SUBJECT: SPECIAL SERVICE CAMPAIGN – S02  
(1993 and 1994 LAND CRUISER O<sub>2</sub> SENSOR)

**Toyota will initiate a Special Service Campaign to replace the O<sub>2</sub> sensors on 1993 and 1994 model year Toyota Land Cruisers.**

**TECHNICAL INSTRUCTIONS**  
**FOR**  
**SPECIAL SERVICE CAMPAIGN S02**

### **III. LOCATION OF AFFECTED PARTS**

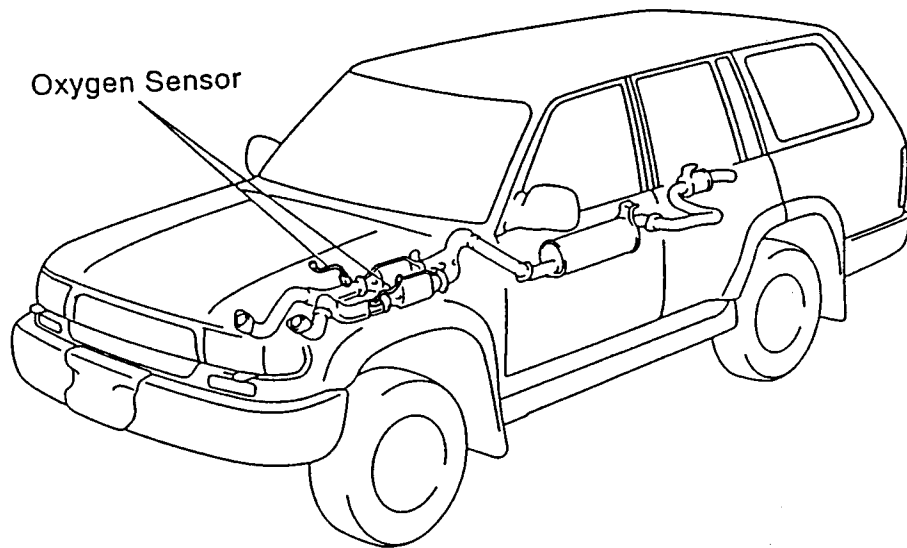
Toyota has determined that the oxygen sensor heater wire on the vehicle may have an open circuit due to repeated thermal stress, causing the Malfunction Indicator Lamp (MIL) to illuminate.
